ADDENDUM 004

project	SDP Sumitomo Dainippon Pharma TI	project no	21560
date	2021-09-02	no. pages	
owner	SDP Sumitomo Dainippon Pharma Oncology		
contractor			
bid date	2021-09-16	bid time	2:00 pm

item	sheet#	description
4.1	A111.0C	Location of relocated light sensor & ceiling tile
4.2	A111.3	Relocate light & sensor ceiling tile
4.3	ED101B	Relocate light sensor & ceiling tile
4.4	EL101	Location of relocated light sensor & ceiling tile

A1 LEVEL 1 LIGHTING PLAN
SCALE: 1/8" = 1'-0"

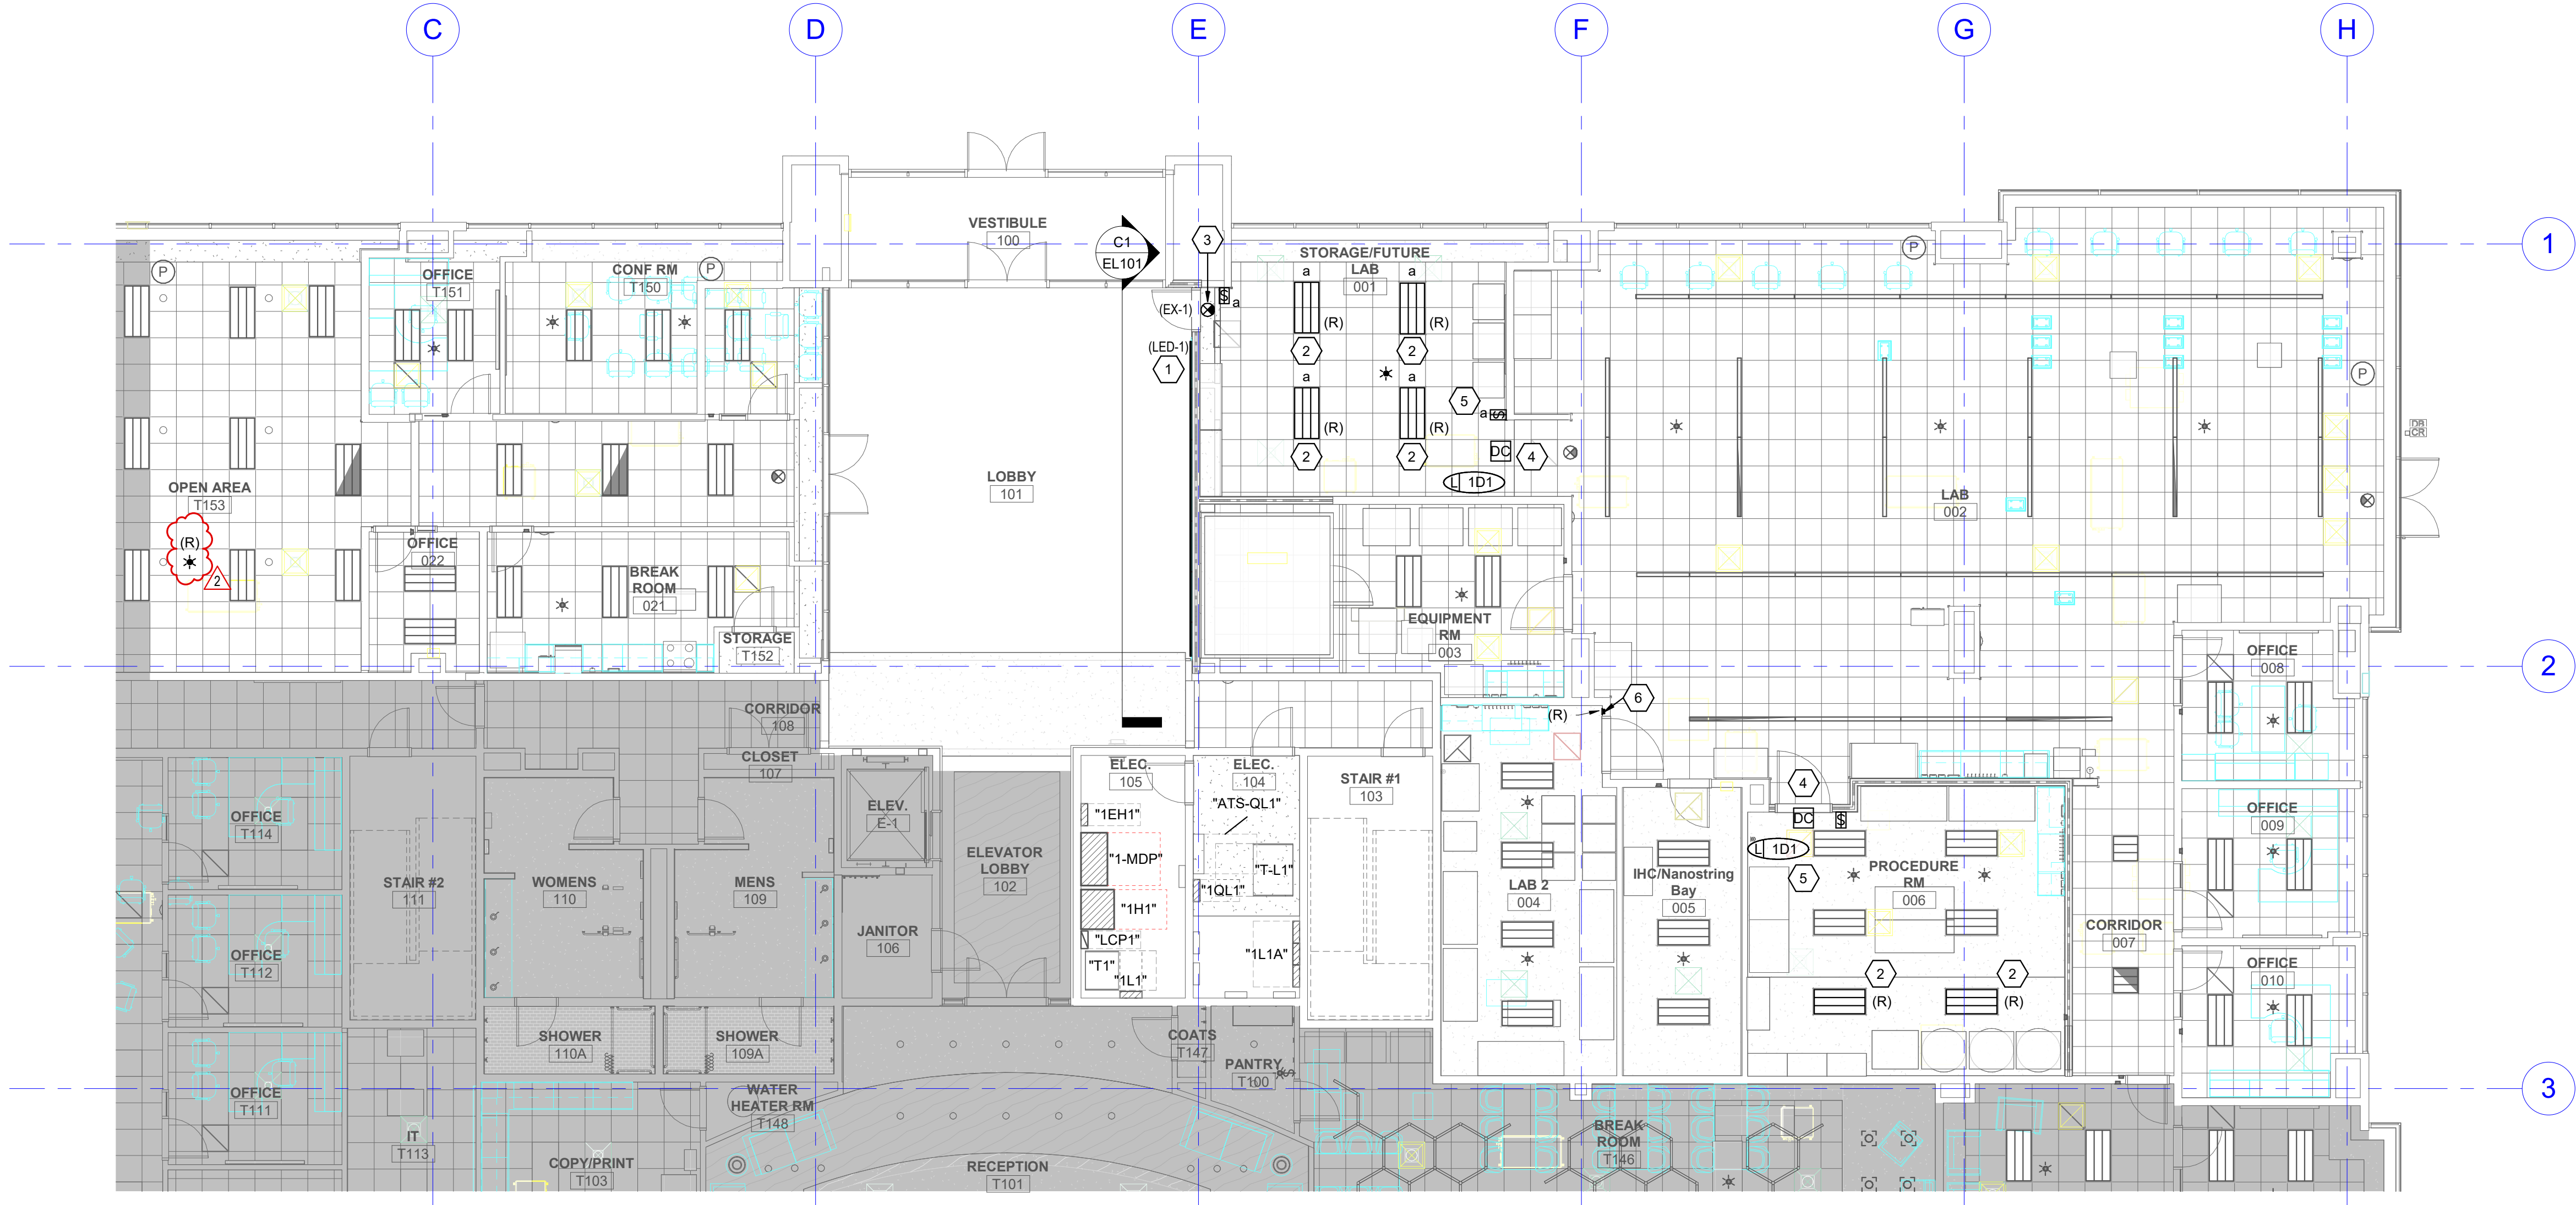
- 5 PROVIDE UPDATED LIGHTING CONTROLS FOR THIS ROOM AS INDICATED. CONTROL ALL LIGHTS WITHIN THE ROOM TOGETHER.
- 6 FIELD VERIFY THAT THE SWITCH AND SENSOR RELOCATION WILL FIT ON INSIDE OF SHORT WALL. OTHERWISE SWITCH AND SENSOR ARE TO BE MOUNTED OUTSIDE THE ENTRYWAY DOOR, ON THE OPPOSITE SIDE OF SHORT WALL.
